Type <b>Coffee Vending Machine</b>	Model <b>9100 - 95</b>	N° T.I. <b>03 - 2022</b>					
Serial Number <b>13521503</b>	Subject <b>OR Material modification of the NTC PROBE</b>	ISSUED FOR (X)	<table border="1"> <tr> <td>Action</td> <td></td> </tr> <tr> <td>Information</td> <td><b>X</b></td> </tr> </table>	Action		Information	<b>X</b>
Action							
Information	<b>X</b>

**New OR gasket - FKM - 1,78X9,25 (green)**

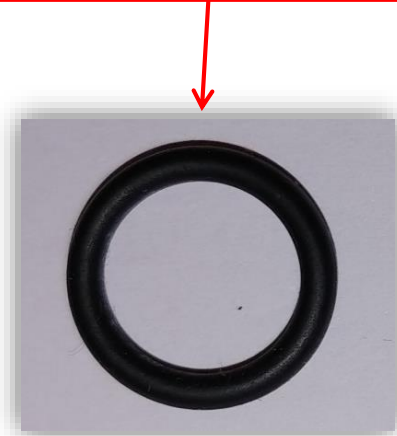
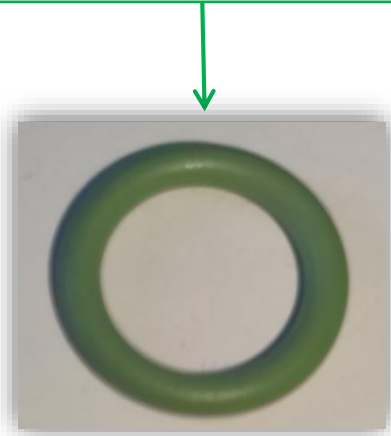
To avoid any hydraulic leakage

The **OR** of the *NTC probe* has been replaced by a **new** one made of **new** material: **FKM** (instead of **EPDM**) that guarantees greater resistance to the working temperatures of the boiler.

Spare code: **11013173/sap 55124924**

**Pre – modific. OR gasket - EPDM - 1,78X9,25**

Spare code: **251556/sap 55116454**

The **new OR** can be used on machines previous the S/N above.
